Transport Response to Section 92 Further Request Bayswater Marina

PREPARED FOR BAYSWATER MARINA HOLDINGS LIMITED | AUGUST 2021

Following submission of the resource consent application (BUN60373319 dated 15 April 2021) by Bayswater Marina Holdings Limited (“**BMHL**”) for the above development, Auckland Council has issued an additional request for further information under Section 92 of the Resource Management Act 1991 (“**further s92 request**”).

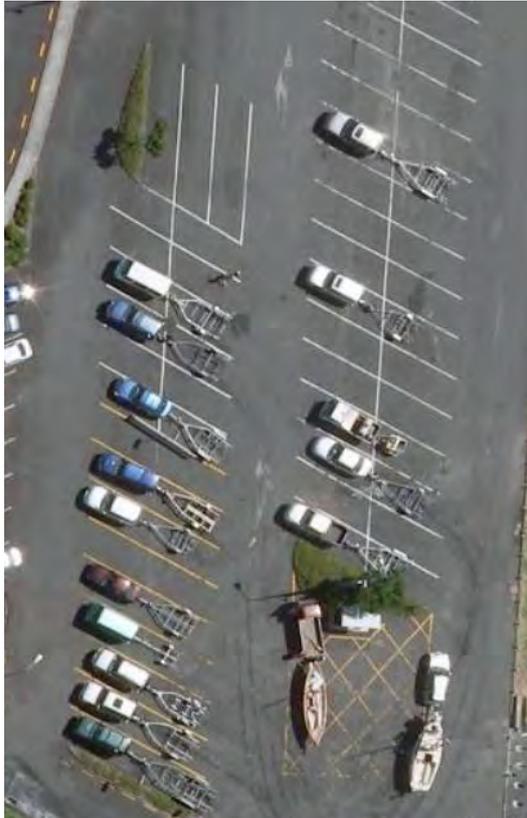
The 1504 Bayswater Marina Precinct Plan in the AUPOP has a requirement for the provision of 20 car and boat trailer parking spaces. The application proposes to have the parking spaces dispersed throughout the site, in relatively ambiguous locations. The majority of the car and trailer parking requires the driver to perform a parallel park manoeuvre to access the park which can be a difficult manoeuvre for some drivers towing a trailer. The proposed location of the trailer parking spaces is not supported for the following reasons:

- c. Several of the car and trailer parking spaces are located inside the residential precincts. Wayfinding is unlikely to be obvious to members of the public to enter what will appear as private property in order to access a marina car park. Once inside the shared space environment, complicated reverse manoeuvring will be required in a space that encourages pedestrians, children playing etc.

- d. The vehicle crossings and the shared spaces inside the residential precincts are excessively wide to allow for the trailer parking inside the precincts. Both the shared space and vehicle crossings widths could potentially be narrowed down significantly to promote slower traffic speeds and a more efficient use of land.

Please consider relocating the car and boat trailer parking to reflect the following:

UPDATED APARTMENT BASEMENT TRACKING ASSESSMENT
 SHEET 1 OF 6

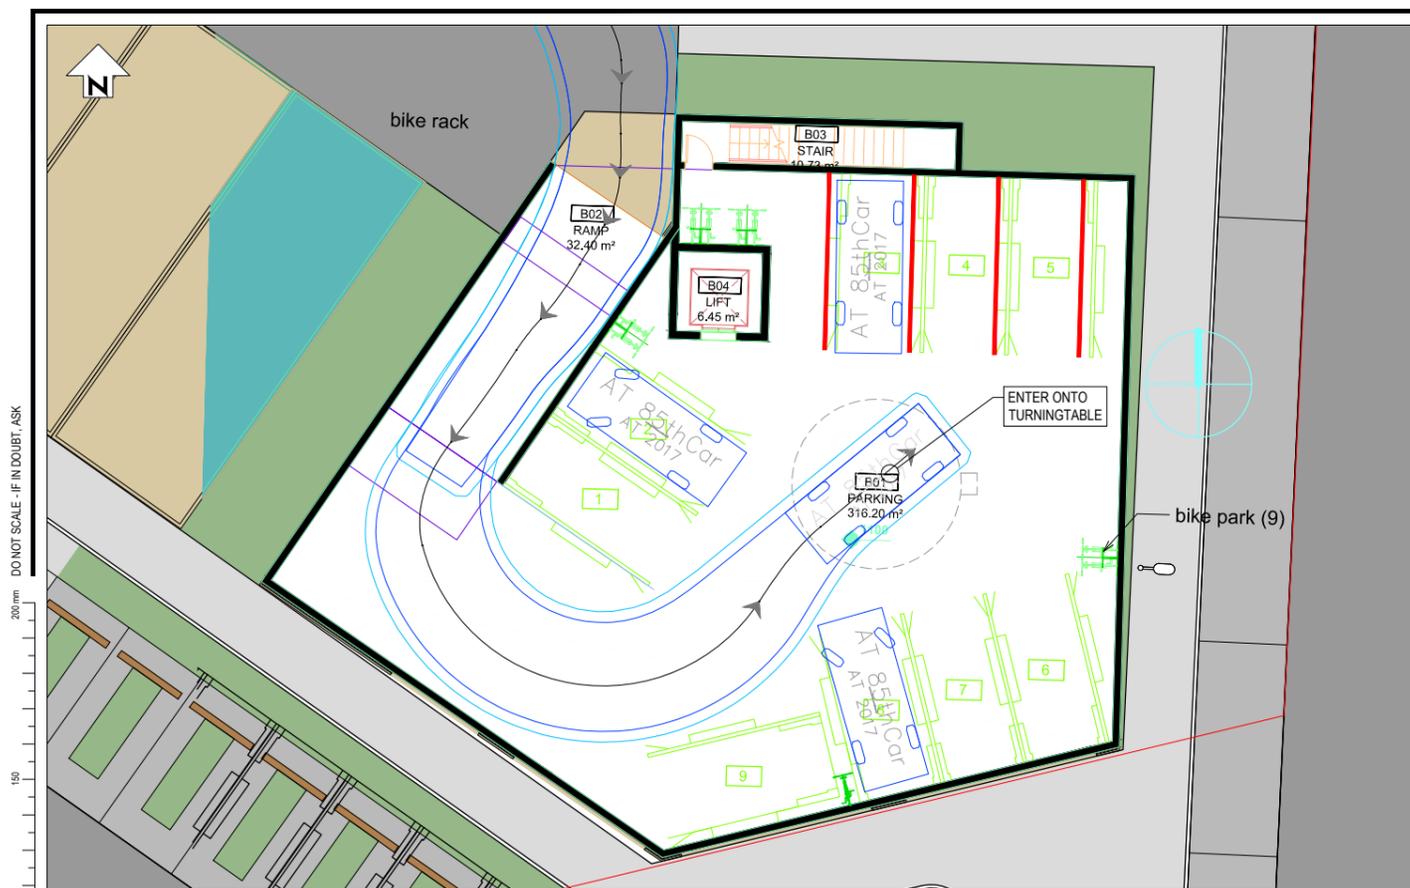
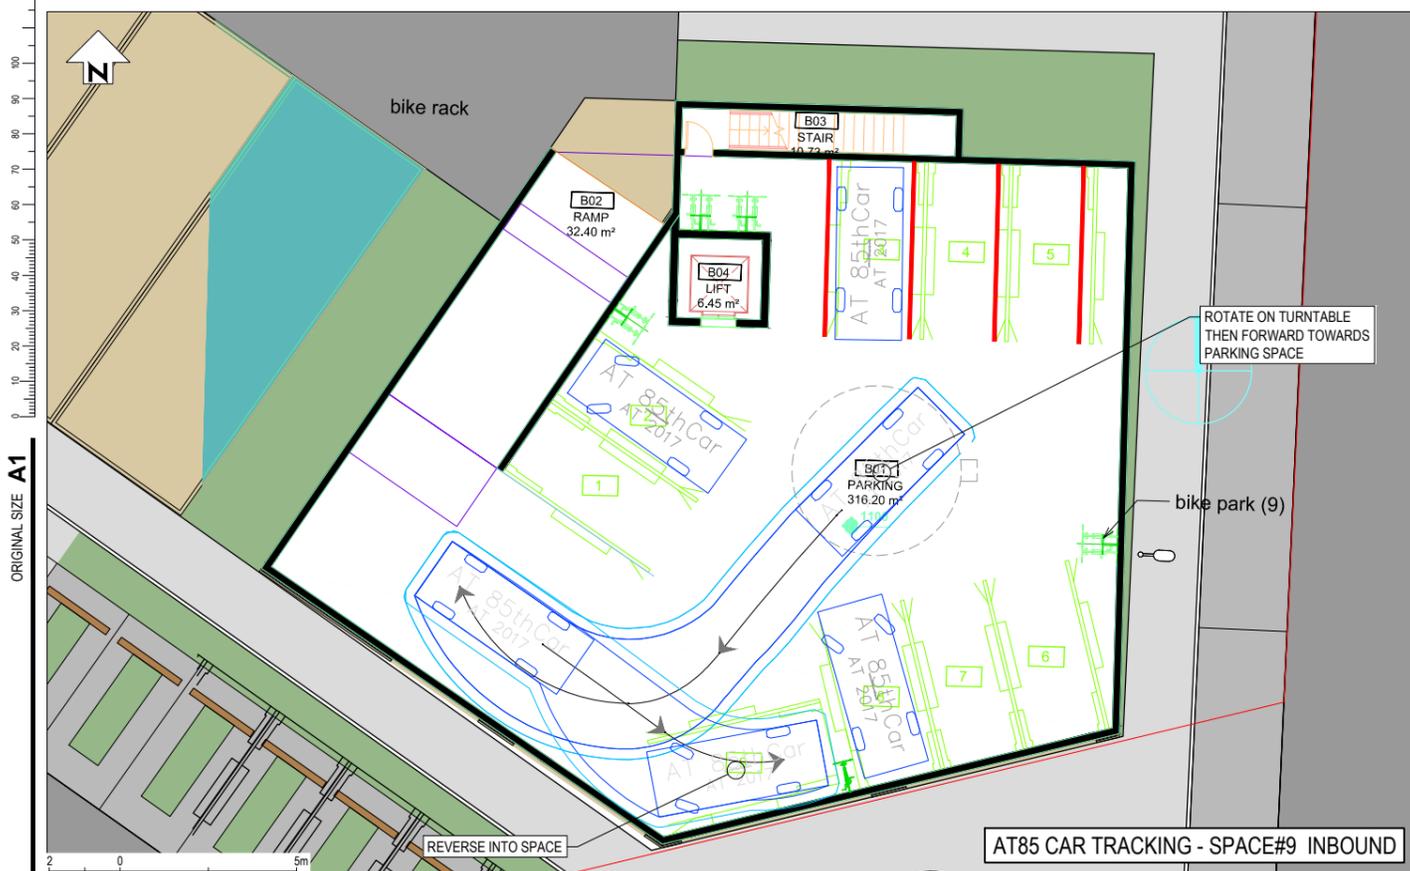
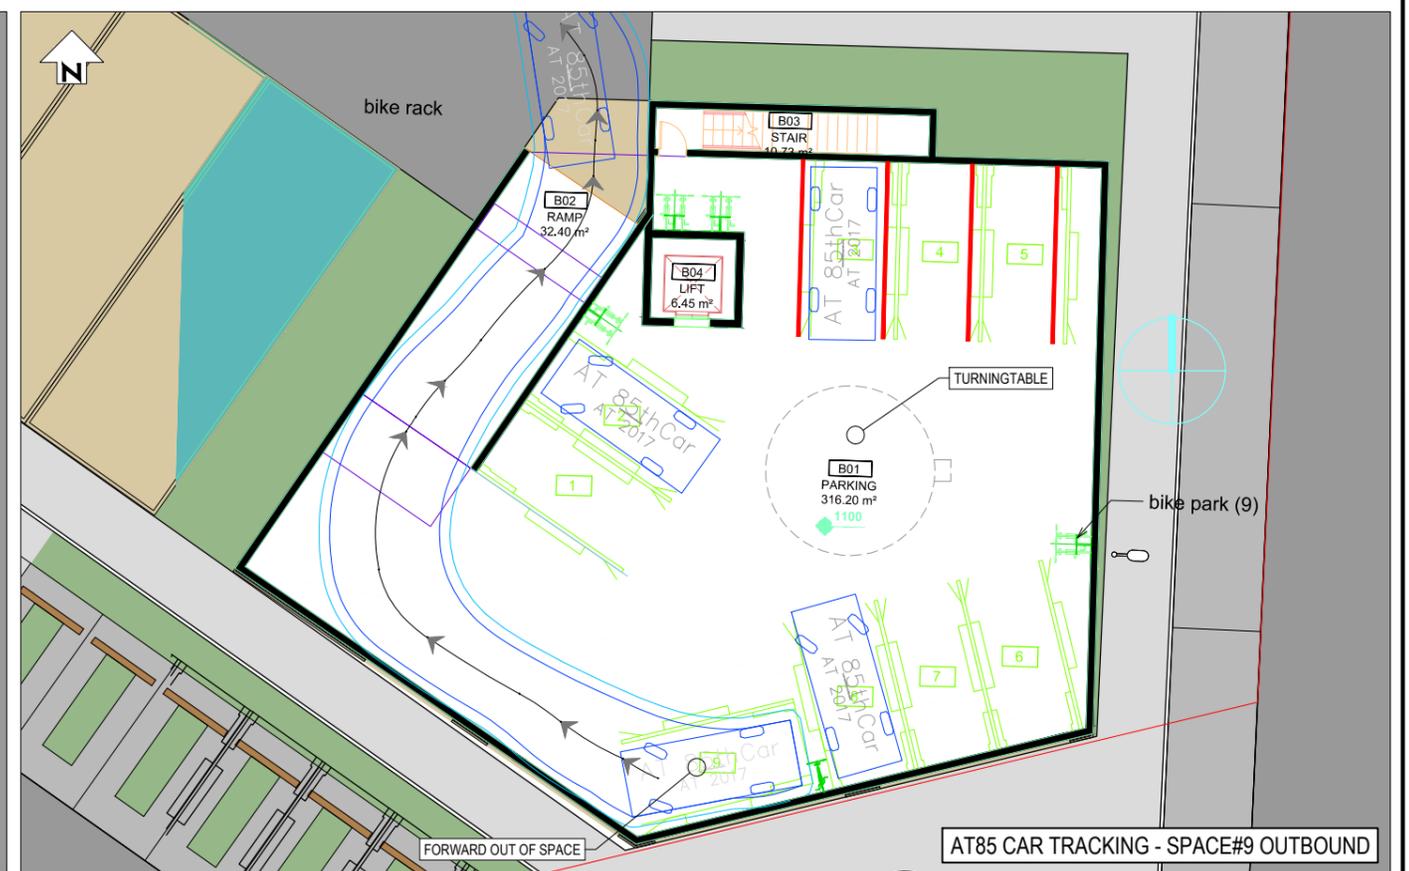
Some of the parking spaces on level B01 of the apartment blocks look like they may have constrained manoeuvring area. Please show vehicle tracking for an 85th percentile car to demonstrate that the parking spaces work.

Stantec provided vehicle tracking for the car parks in the apartment buildings. The vehicle tracking looks tight, irregular (wheels need to come to a complete stop to fulfil a manoeuvre) and in some cases track over other parking spaces or ramps. Stantec’s response acknowledged the constraints in the tracking and stated that turntables will be provided. Please provide details of the turntables and revise the tracking accordingly.”

Turntables of 4.8m in diameter (or similar) will be provided as required. Typical specifications for such a turntable are attached as **Appendix A**. It is noted that the detailed design of the required turntables will be explored during subsequent detailed design stages, where the exact position (in terms of structural integrity) will be reviewed and confirmed.

An updated vehicle tracking assessment (inclusive of the provision of turntables) is provided in **Appendix B**.

As can be seen, with the provision of turntables, vehicles can access to the more constrained parking spaces is greatly improved. As noted, the exact positions and design of these turntables will be provided during detailed design stage.

UPDATED APARTMENT BASEMENT TRACKING ASSESSMENT
SHEET 3 OF 6

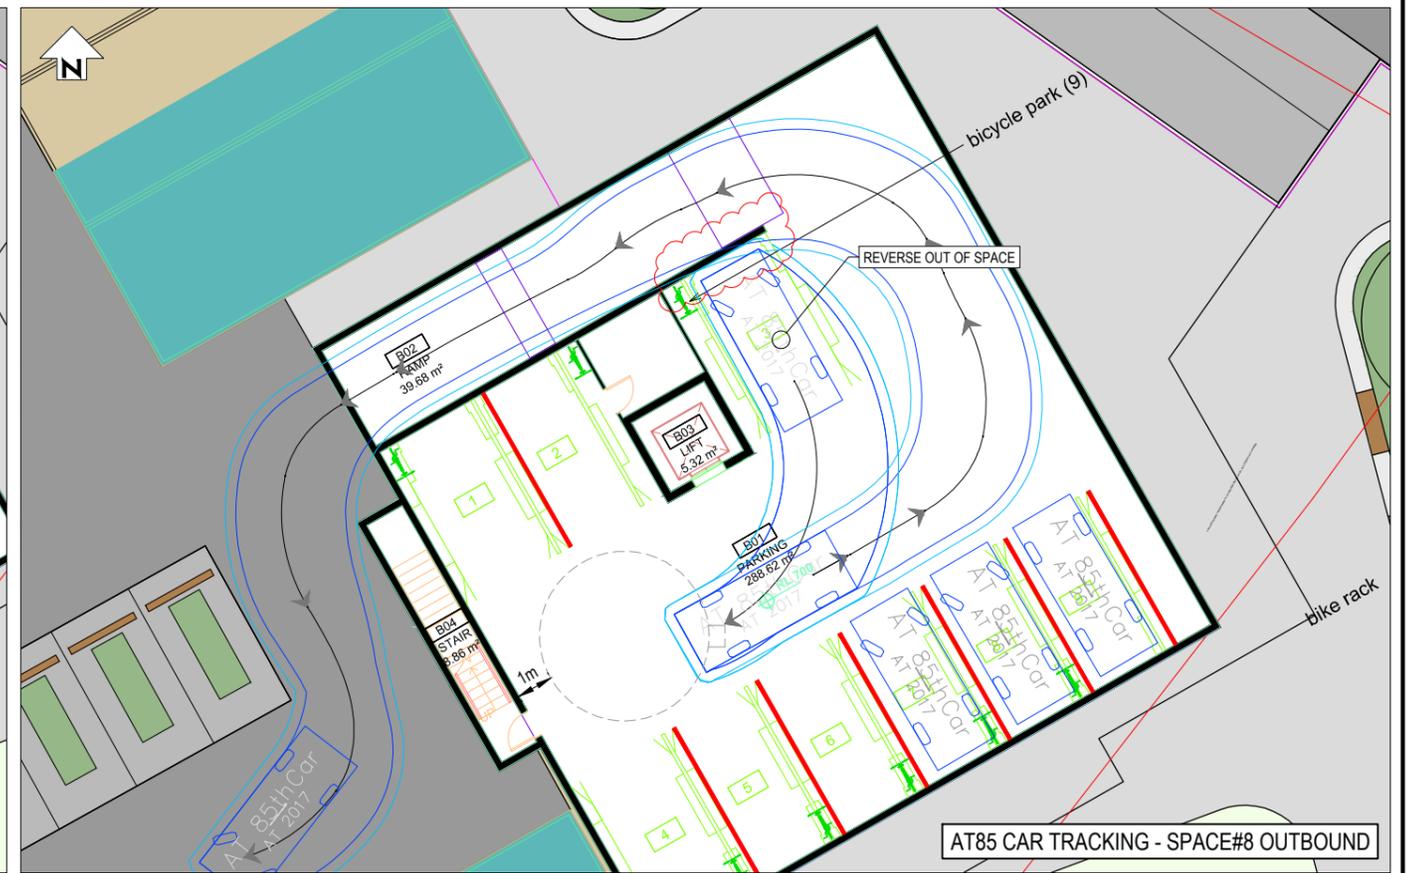
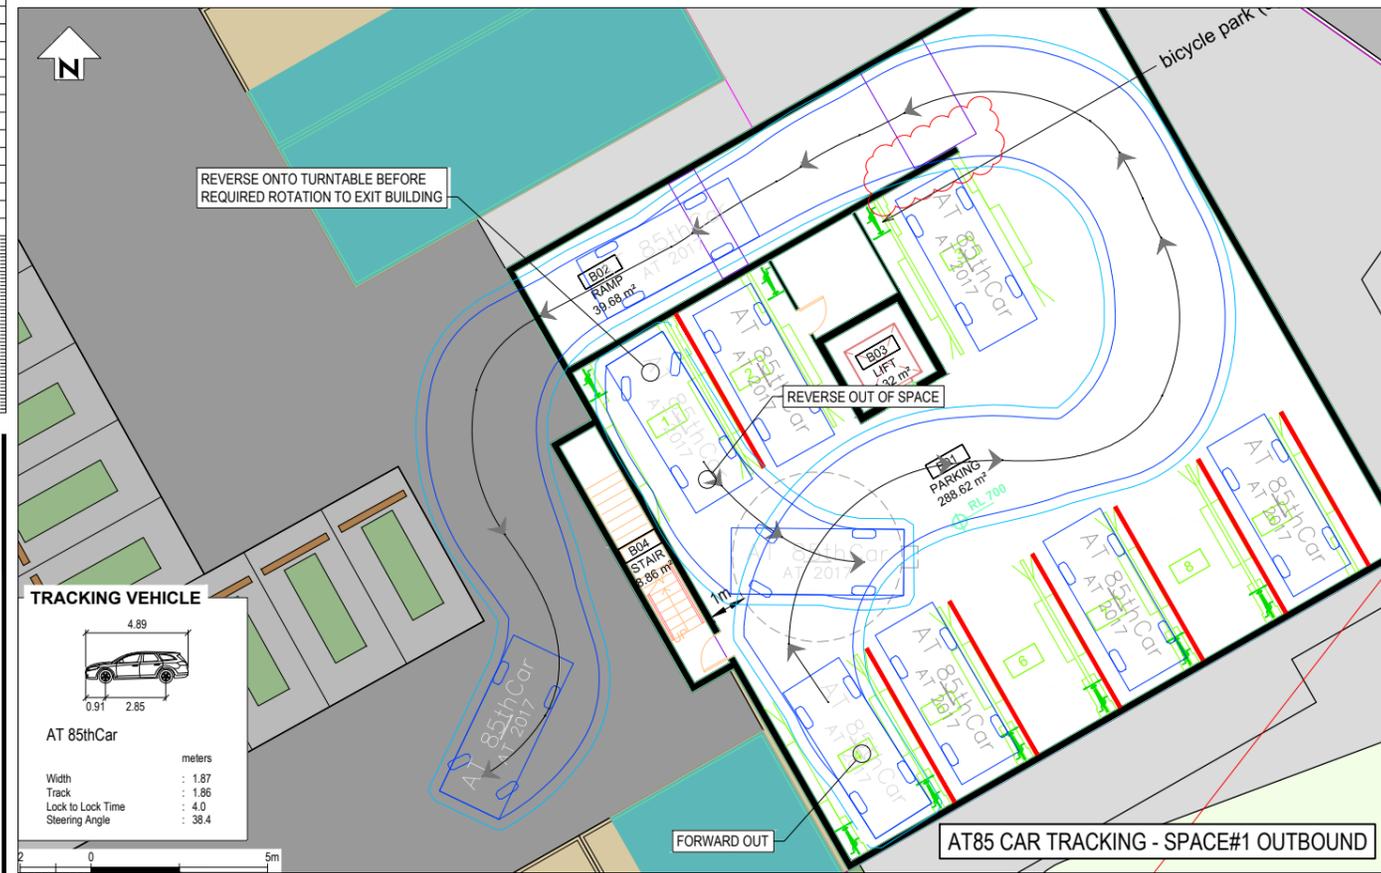
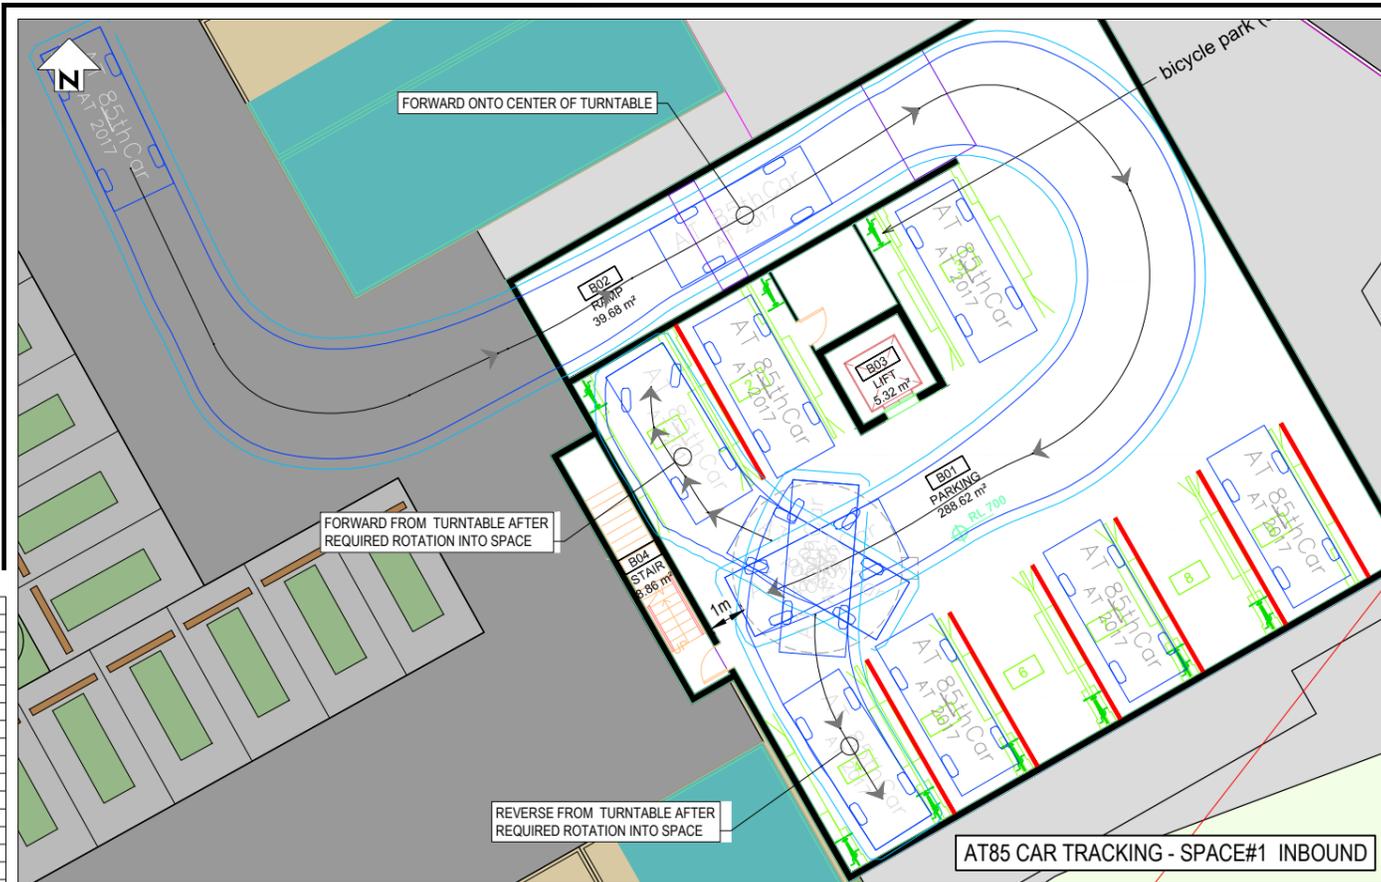
- i. *The Long section for the north apartment ramp provided on Drawing 320 does not appear correct, with the basement ramp not starting from the ground level. Please clarify or correct.*
- ii. *Stantec's response indicates that the access ramps for the apartment buildings are 3.4m wide, however the drawings for the Central Apartment building shows a 3.1m wide access ramp. This is considered too narrow for a ramp with walls on either side of the ramp. Please widen this ramp to a minimum of 3.4m.*
- iii. *The entry to the Northern Apartment building appears to be at a challenging angle. Please provide vehicle tracking showing an 85th percentile vehicle entering and exiting the access. The tracking should include a vehicle entering from the direction of the one-way system in the residential precinct."*

- iii. Sheet 3 of 6 in Appendix B provides a tracking assessment of the inbound and outbound movement of this ramp. The tracking confirms that the northern apartment basement can be access safely and conveniently.
